JUAN SANCHEZ BOULEVARD
EXTENSION TO LEVEE
PLAN AND PROFILE
BEGIN PROJECT TO STA 37+50

SHEET P-1
APRIL 23, 2018

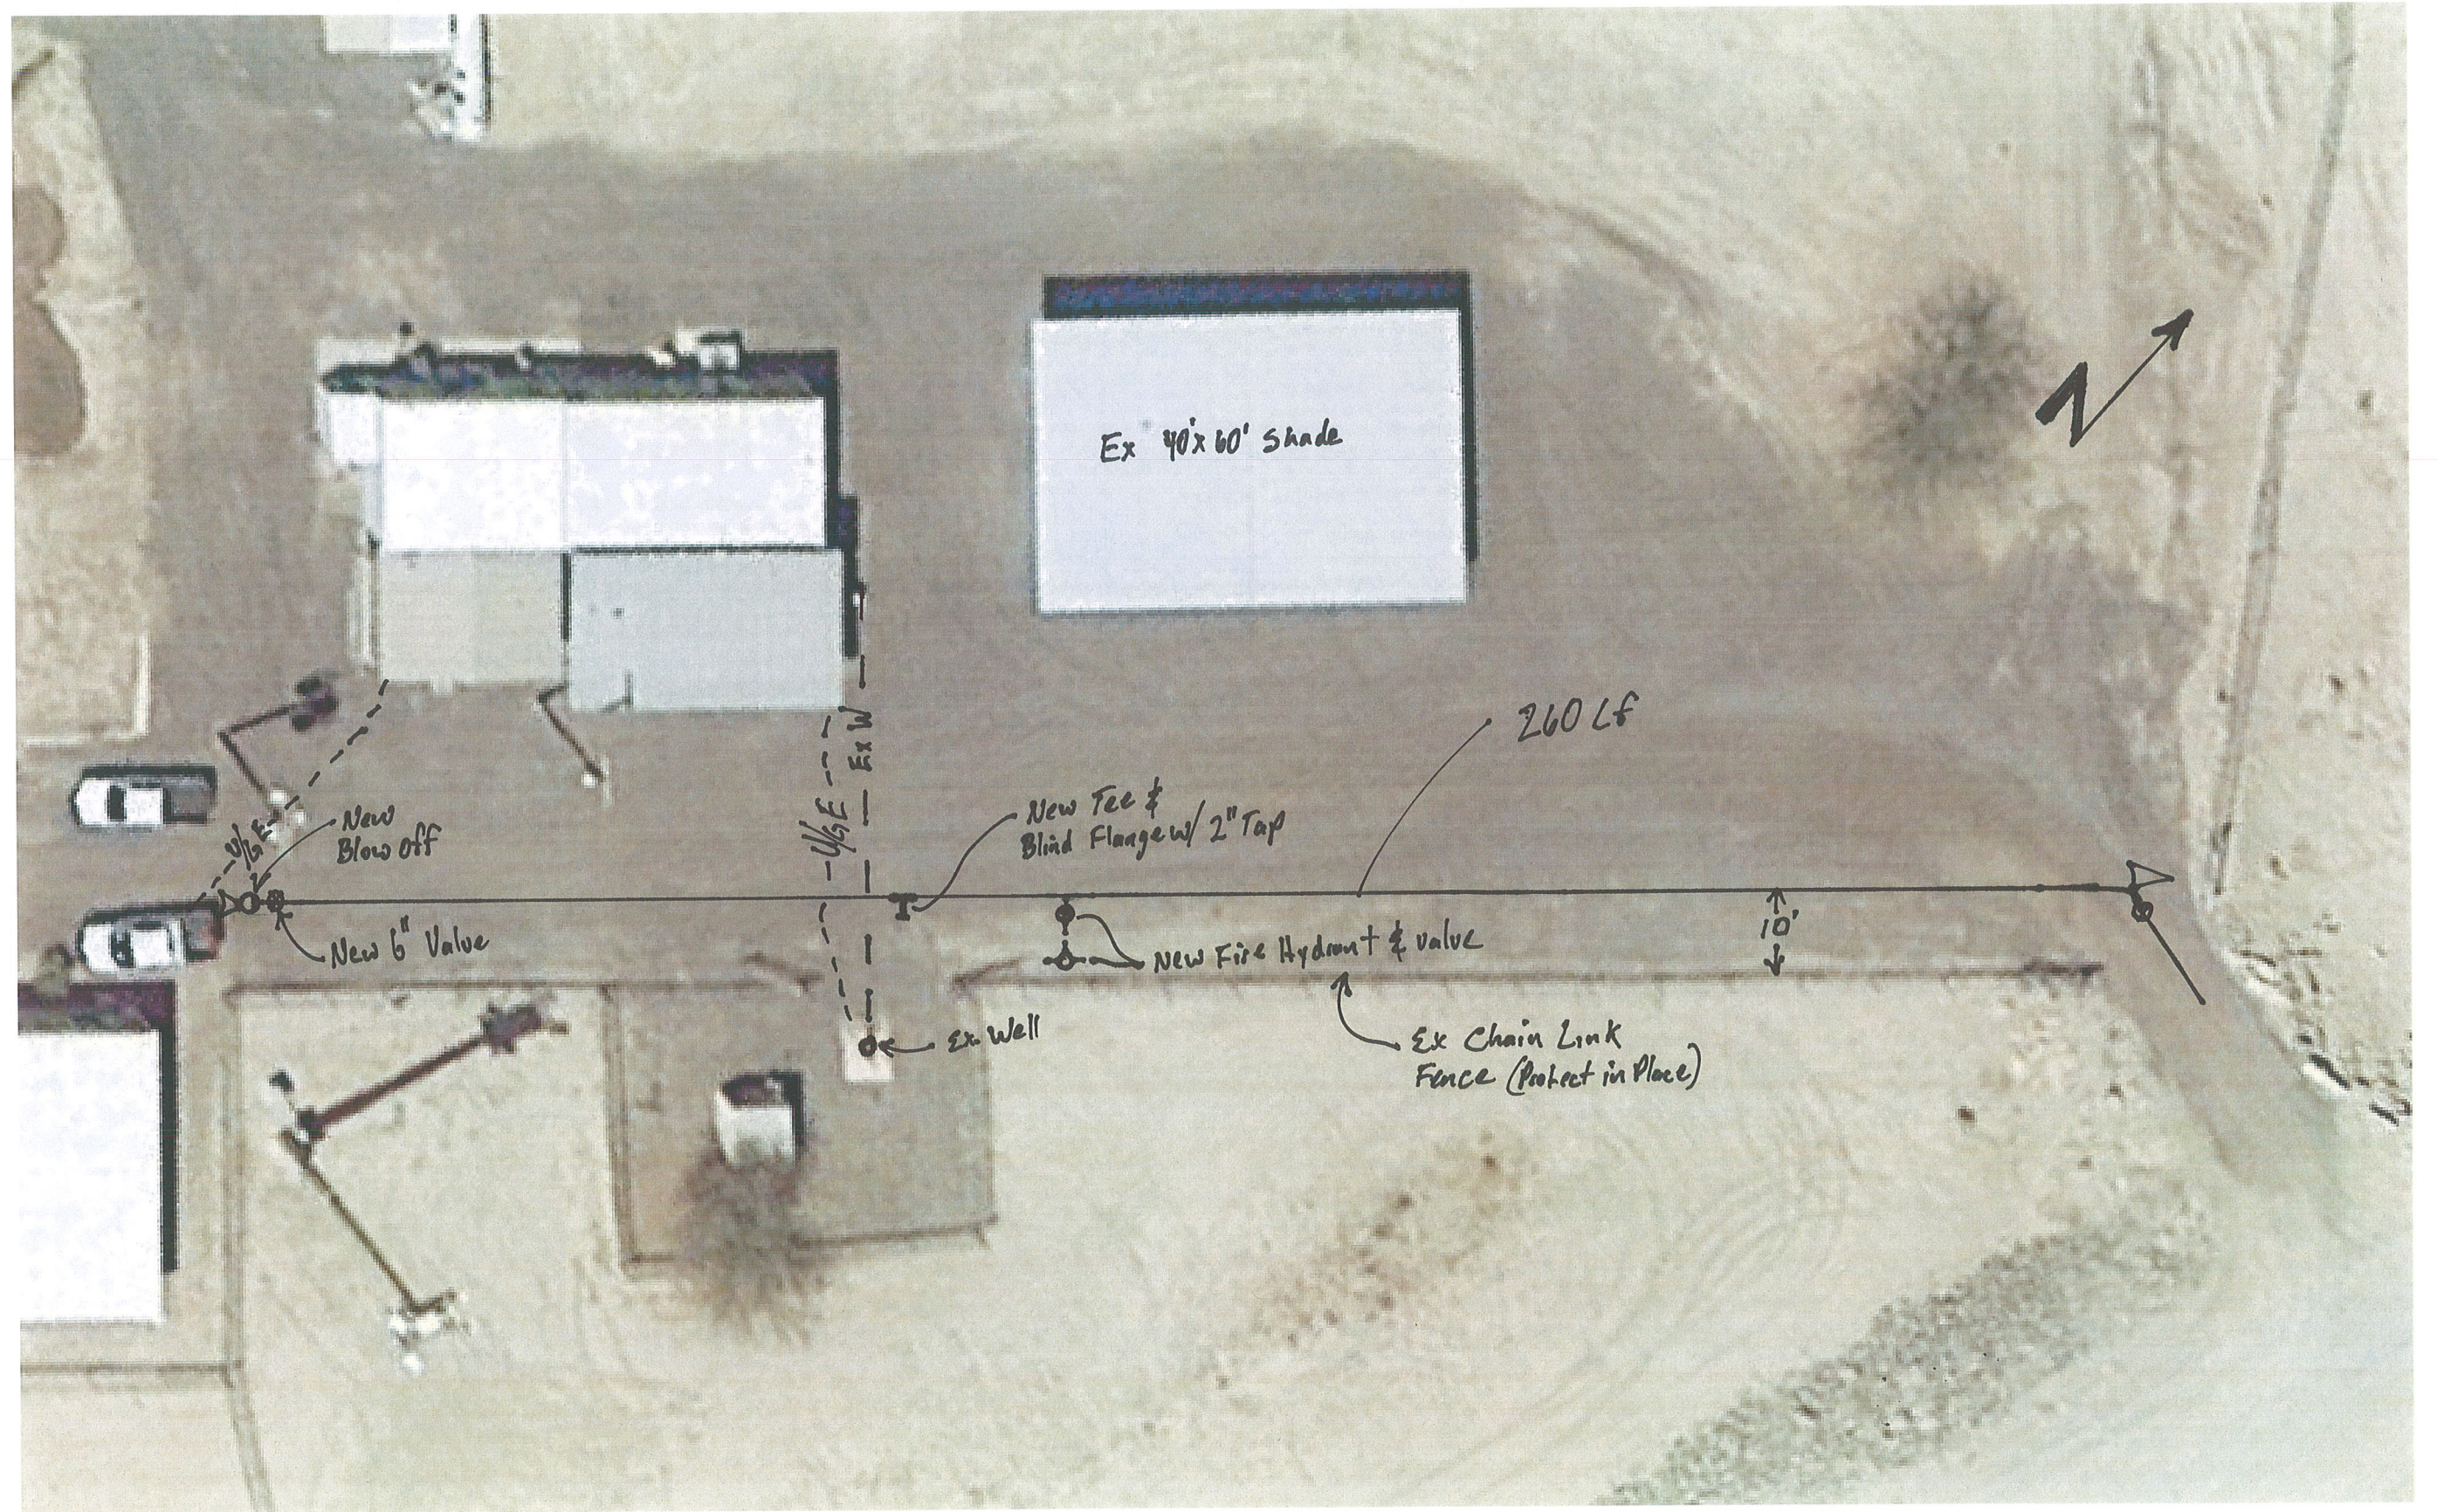
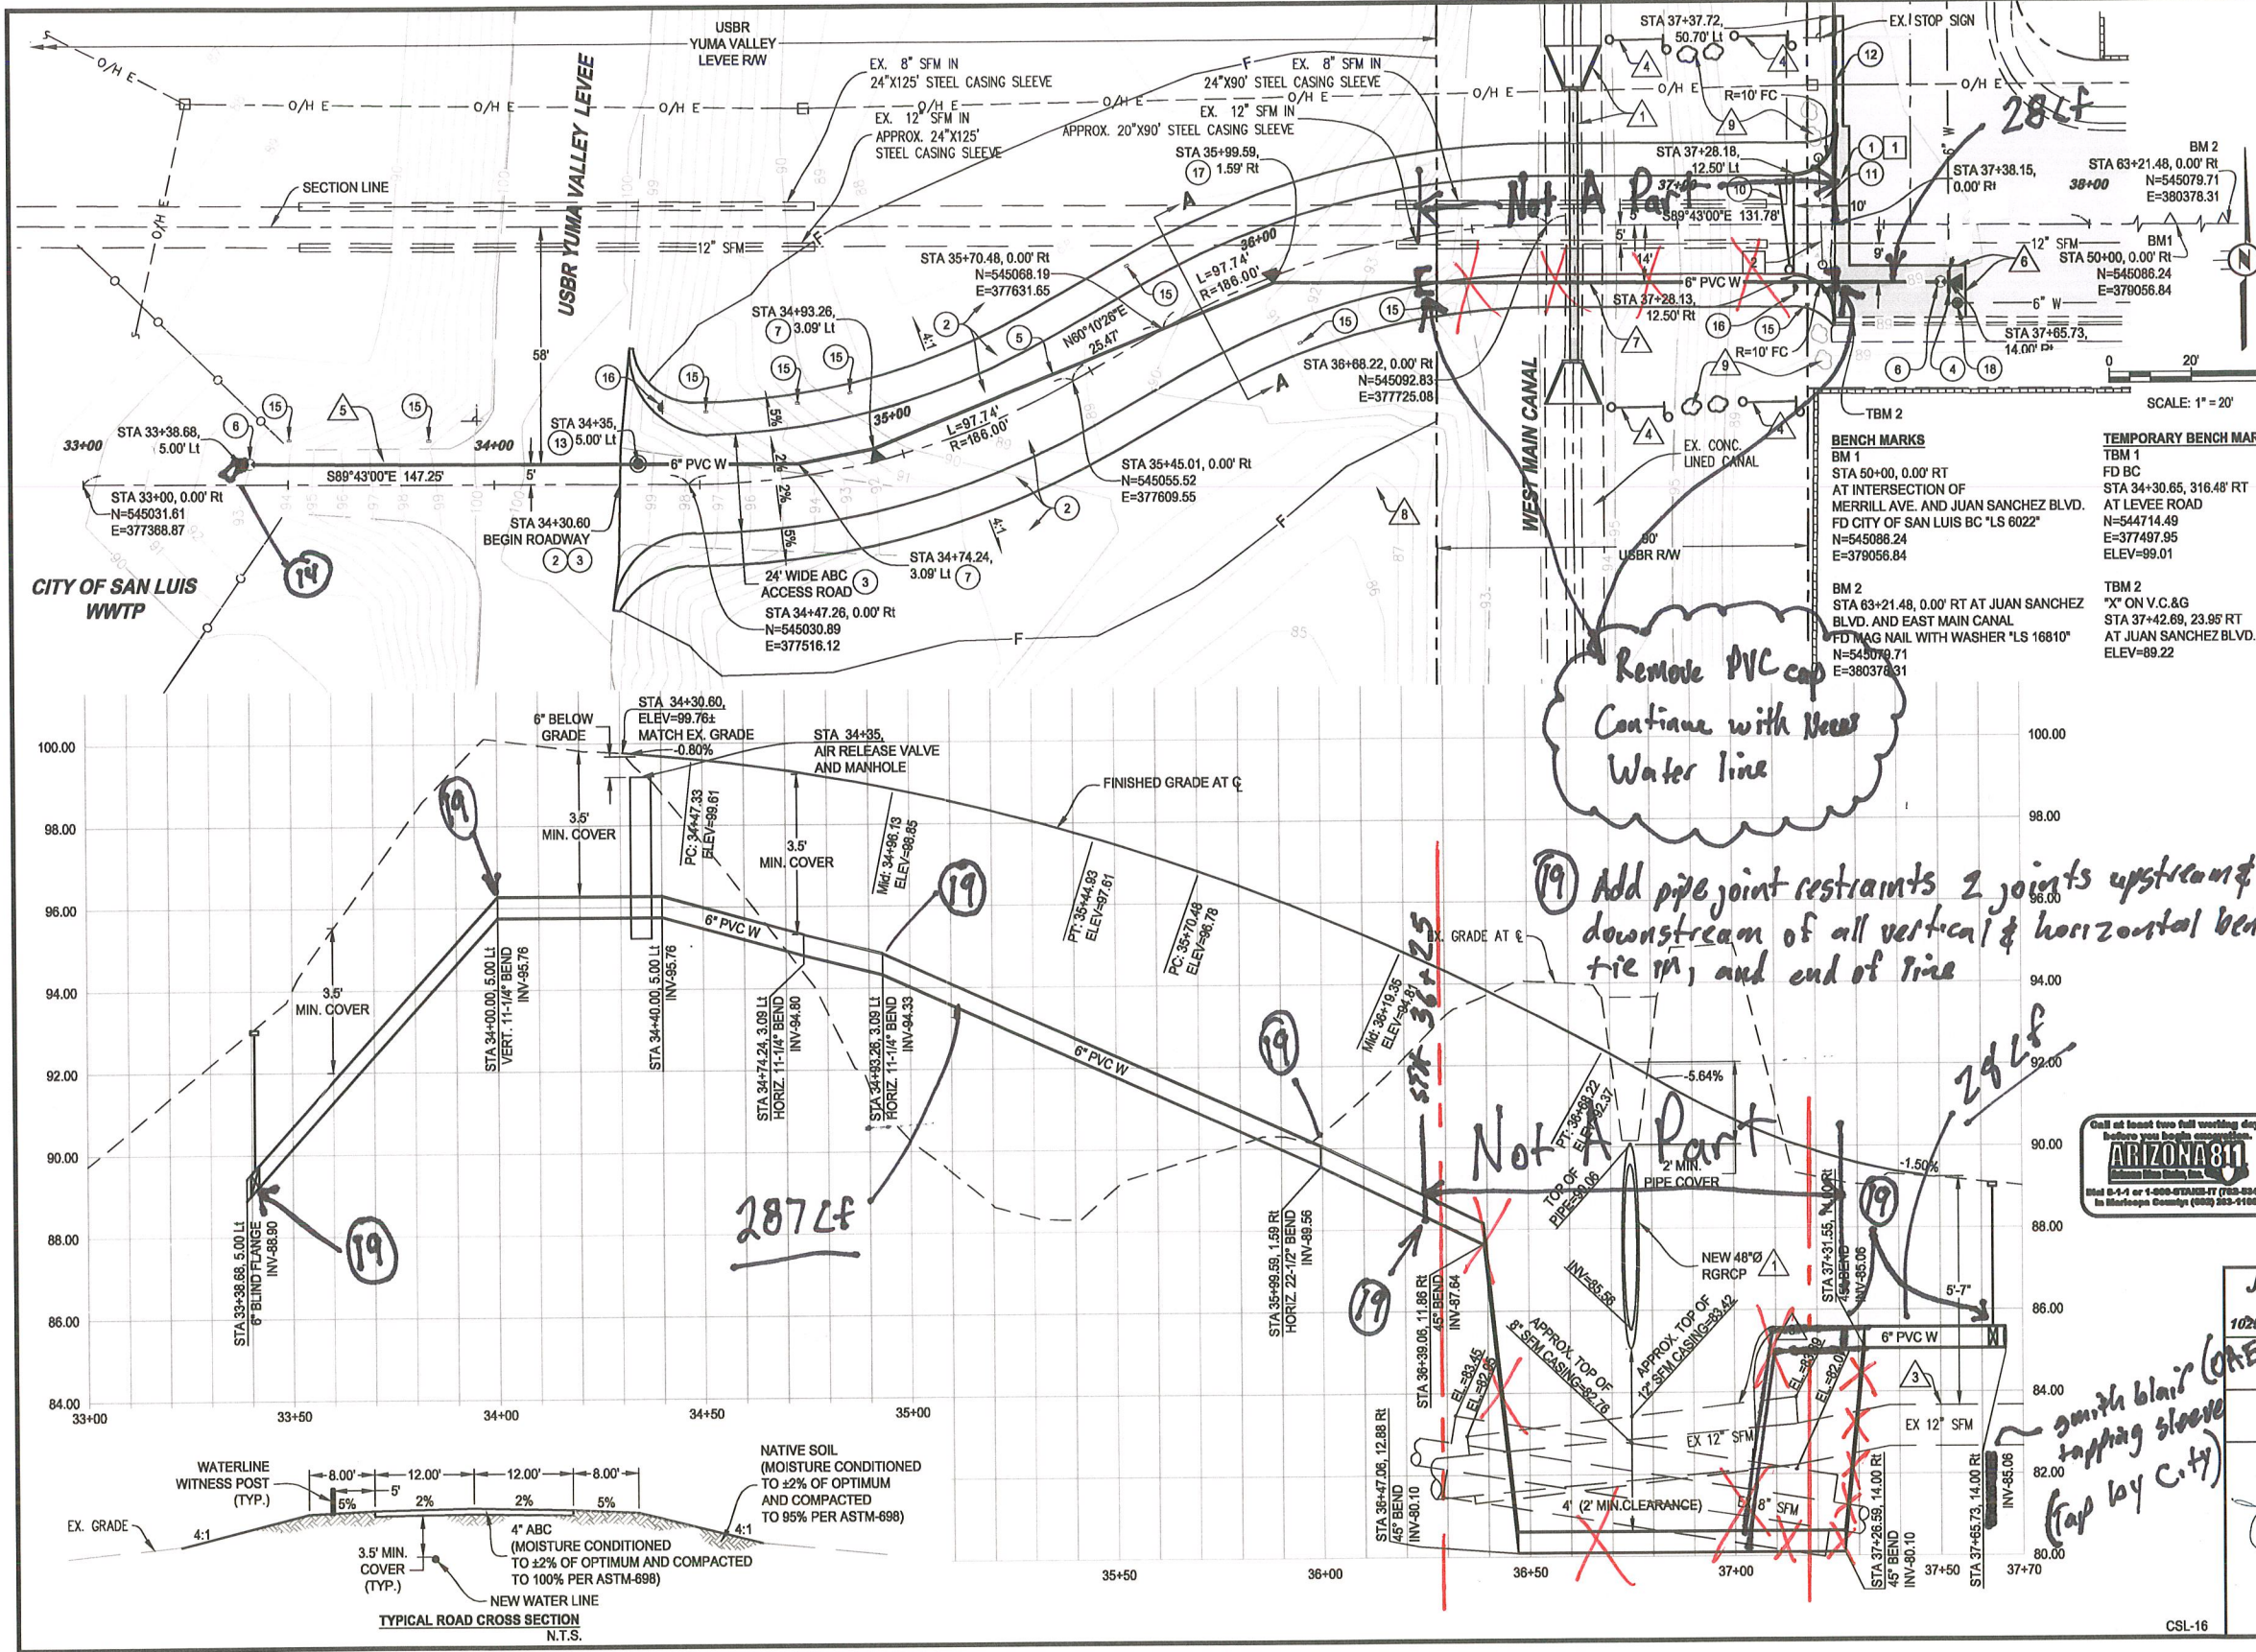
Ex 40'x60' shade

260 LF

New Tee & Blind Flange w/ 2" Tap

New Fire Hydrant & valve

Ex Chain Link Fence (Protect in Place)

Ex Well

New Blow Off

New 6" Valve

10'

1/2" E
Ex W
